Austin Light Rail Phase I Project (Permit 31726)

Re: *Project Review Under Section 106 of the National Historic Preservation Act, Austin Light Rail Phase 1 Project, Draft Built Environment Survey Report, Austin, Travis County (FTA/106, THC #202500480)*

**From:** Deron Lozano <Deron.Lozano@atptx.org>  
**Sent:** Monday, September 9, 2024 1:58 PM  
**To:** scott ford <scott.ford@txdot.gov>; Gruta, Gabriel <Gruta.Gabriel@epa.gov>; amy grossman <amy.grossman@tpwd.texas.gov>; Houston, Robert <Houston.Robert@epa.gov>; Joseph Shelnut <Joseph.L.Shelnutt@usace.army.mil>  
**Cc:** Plaskon, Terence (FTA) <terence.plaskon@dot.gov>; Lynn Hayes <lynn.hayes@dot.gov>; Jillian Mauer <mauer@pinyon-env.com>; Rachel Thomas <rachel.thomas@atptx.org>; Jennifer Pyne <Jennifer.Pyne@atptx.org>; Underwood, Tom <tom.underwood@hdrinc.com>; support@contigotx.com  
**Subject:** Austin Light Rail Phase 1 - Cooperating Agency ADEIS Submittal - comments requested 9/27

**From:** Shelnut, Joseph L CIV USARMY CESWF (USA) <Joseph.L.Shelnutt@usace.army.mil>  
**Sent:** Friday, September 27, 2024 1:35 PM  
**To:** Plaskon, Terence (FTA)  
**Cc:** Deron Lozano  
**Subject:** Austin Light Rail Phase 1 - Cooperating Age

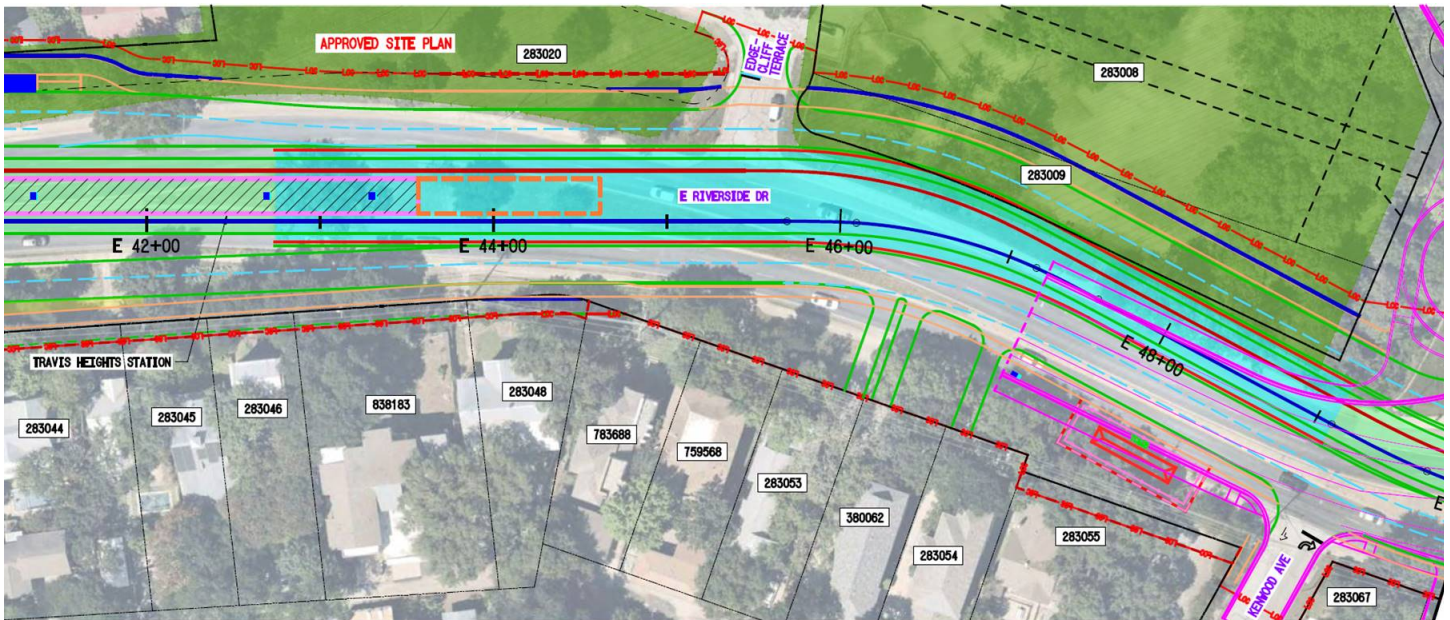
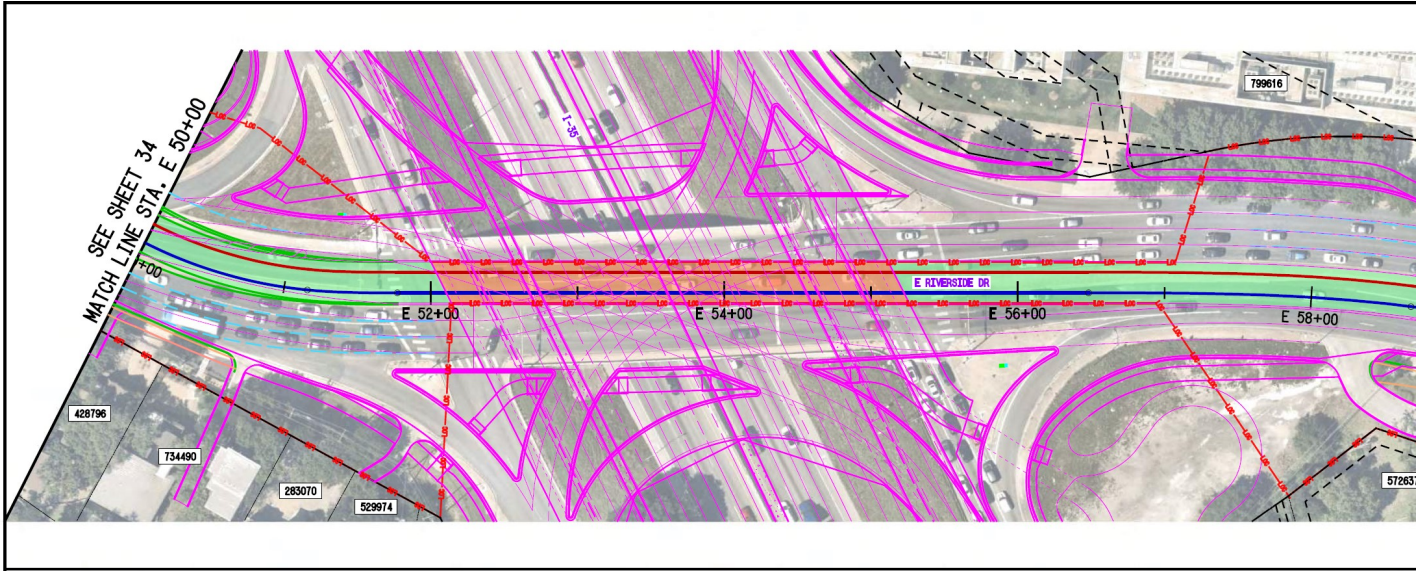
Also, confirmed the pink linework matches the latest CapEx-C LBL let plans (see snapshots below from the provided PDF, proposed work by others - CapEx-C LBL project), thanks.
